**INDEPENDENT
ADVISORY PANEL FOR
UNDERGROUND MINING**

**RUSSELL VALE UNDERGROUND
EXPANSION PROJECT**

November 2020

EXECUTIVE SUMMARY

Figure 2: Location and nature of workings in each of the three seams at Russell Vale, sourced from SCT (2020b) and annotated to identify longwall panel numbers in the Wongawilli Seam.

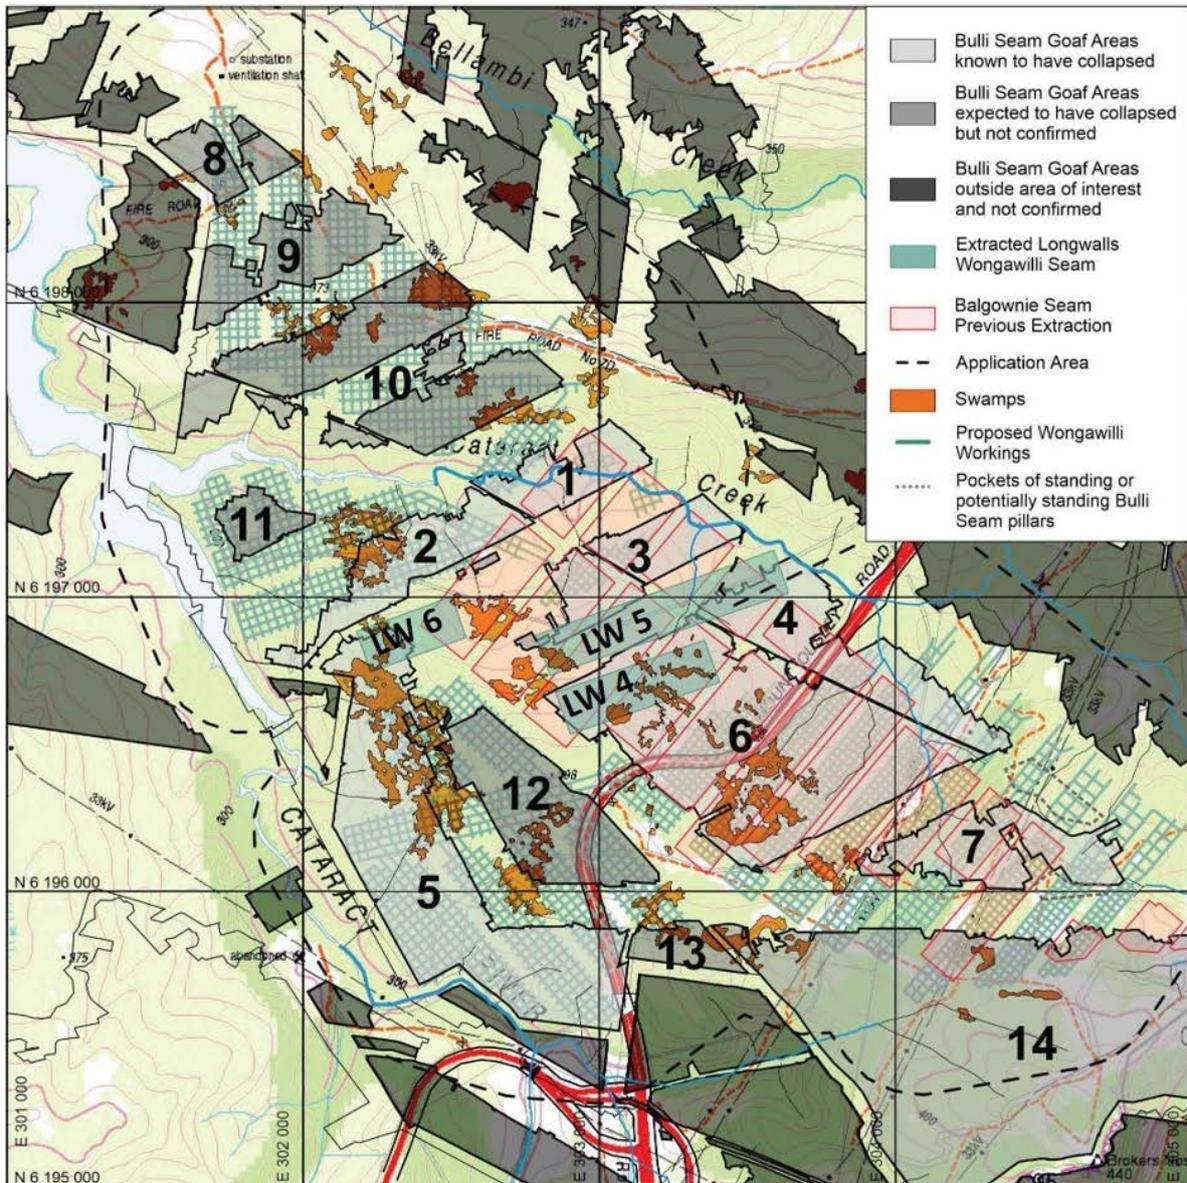
In order to assess the implications of the SCT approach to endeavouring to conform to the advice of IESC, the Panel has had regard to subsidence effects associated with multiseam mining in the past at Russell Vale Colliery.⁶ Figure 2 shows the location and nature of workings in each of the three seams extracted to date and Figure 3 shows the location of overlying swamps. The following summary characterises these mining operations. Because monitoring was very limited at the time of extracting the top two seams, subsidence effects due to mining in these seams can only be estimated and there is variability in estimates between the various reports that contain this information.

Based on the layout of mine workings shown in Figure 1, the lateral extent (W) of collapsed workings in Area 6 is much greater than their depth below surface (H). Consistent with the subsidence engineering principles shown in Figure 1, the floor of the Bulli Seam over most of Area 6 should therefore be subjected to full cover load. In turn, longwall mining in the Balgownie Seam will result in caving of the 5 to 10 m parting to the floor of the Bulli Seam and, thus, should result in the full cover load being transferred to the floor of the Balgownie Seam. This contrasts with the pillar stability analysis reported by SCT which is based on the pillars in the Wongawilli Seam only having to support some 65% of the overburden load. If the 19.5 m square pillars are subjected to full overburden load, their factor of safety drops to 1.4, corresponding to around a 2 in 100 likelihood of pillar failure, which is some 2000 times greater than for 24.5 m square pillars.

Reference to Figure 2 shows that these seven areas have been undermined by longwall mining in the Balgownie Seam, some 5 to 10 m below the Bulli Seam. The Panel interprets the SCT statement to mean that the subsidence measured as a result of longwall mining in the Balgownie Seam confirms that the workings were already in a collapsed state prior to longwall mining in the Balgownie Seam.

Figure 3: Identification and location of swamps in area of interest (SCT, 2020b) .

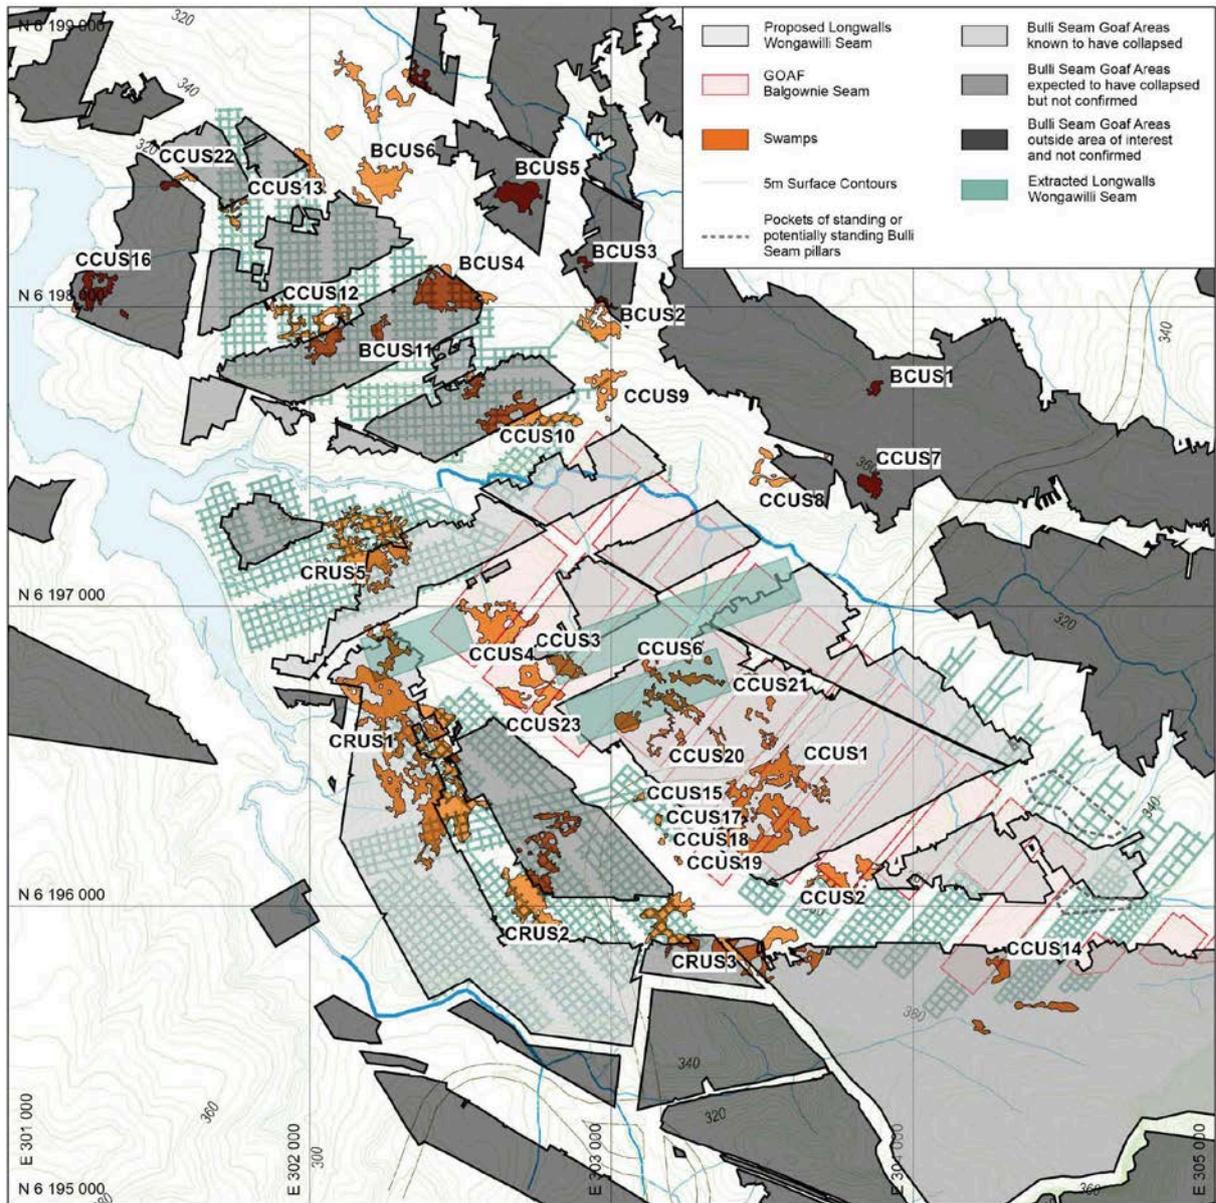
6. As a point of reference, swamp CCUS4 was a particular point of focus in the PAC's 2014 determination of the length of LW 6. The swamp lies predominantly over LW 6 as shown in Figure 3, the extraction of which was predicted to result in a maximum increase in incremental tensile strain of 11 mm/m. The 2014 PAC concluded that
